Historic Architectural Review Commission Staff Report for Item 18

Application Number: C2025-0057

Address: 417 Elizabeth Street (rear)

Renovations to historic one-story house. New accessory structure, new covered entry porch on west elevation, new decking, new one-story addition on north elevation, and site improvements.

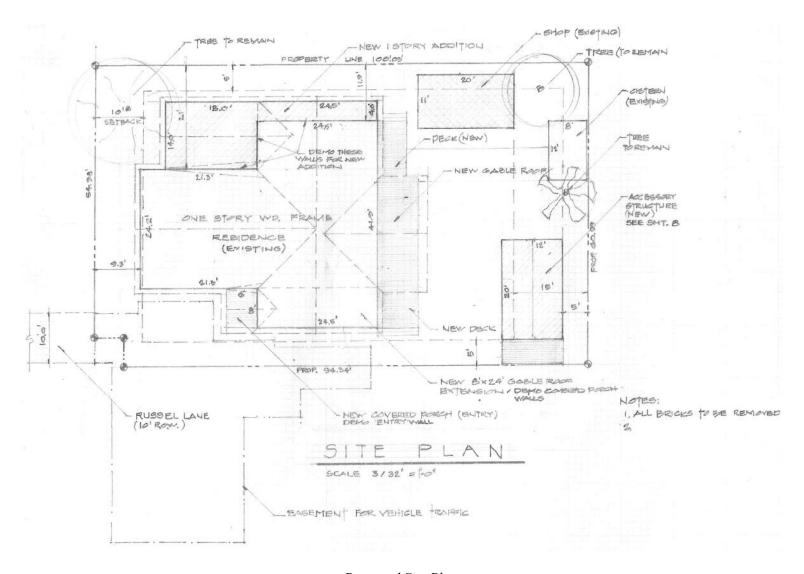
On the south elevation, the applicant proposes an 8' x 24' gable roof extension within the existing building footprint, along with the removal of existing jalousie windows to be replaced with 2-over-2 windows. The west elevation will feature a new covered entry porch with a gable roof, a half-glazed entry door, and sidelights. The north elevation includes the proposed addition with new vertical and 2-over-2 windows, including a triangular clerestory-style window.

The east elevation will include a new IPE deck with a new gable roof structure above, two sets of aluminum bifold doors (12' and 8' openings), a pass-through window, and a triangular window behind the proposed truss.

The proposed alterations raise some concerns regarding consistency with the HARC Guidelines. The existing roof is being significantly modified and extended across multiple elevations to accommodate new additions. According to Guideline 4 under *Roofs*, the form, pitch, materials, and shape of a roof must not be altered unless restoring it to a verifiable historical form. Guidelines 20 of *Additions* states that expanding the existing building form and massing in order to add height to exterior walls is not an appropriate design solution. Guideline 24 of *Additions* discourages the use of same wall plans or cornice height.

Proposed two-story accessory structure.

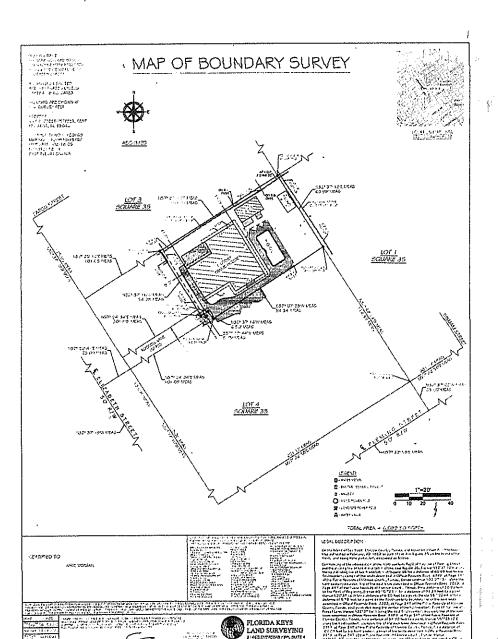
A new two-story accessory structure is proposed on the site. It will be 23' in height, which exceeds the height of the principal structure (approximately 19'), and includes a spiral stair, shop on the ground floor, and second-floor office space. Exterior materials for both primary and accessory structures include 5V-crimp metal roofing and wood lap siding to match the existing.

Upon staff review, it was determined that the accessory structure portion of the submittal lacks several essential components required for proper evaluation by both HARC and Planning. Key issues include the absence of the spiral staircase on the site plan, only one elevation provided, vague and incomplete floor plans, a second-story porch that appears to encroach into required setbacks, and an inaccurately depicted bump-out on the first floor. Due to these inconsistencies, staff recommends removing the accessory structure from this application and resubmitting it separately with complete and accurate information to allow for proper review.

The proposed two-story accessory structure, at 23 feet in height, also exceeds the height of the principal historic structure, which is approximately 19 feet tall. This conflicts with Guideline 11 under *Additions*, which states that additions must be subordinate in size and scale to the contributing structure and must not exceed the original building height. Guidelines 13 of *Additions* states that additions shall be smaller than massing found in the existing building and adjacent structures. Additionally, Guideline 3 of *Accessory Structures* states that accessory structures should not exceed the height of the principal building on site.

Staff recommends that the HARC Commission to exclude the accessory structure from this application review and resubmit it separately with complete and accurate information to allow for proper review. Therefore, staff also recommends that the applicant revise the design to reduce the height of the proposed accessory structure. For the main structure, staff recommends eliminating or reconfiguring non-traditional window shapes and preserving the original roof form.
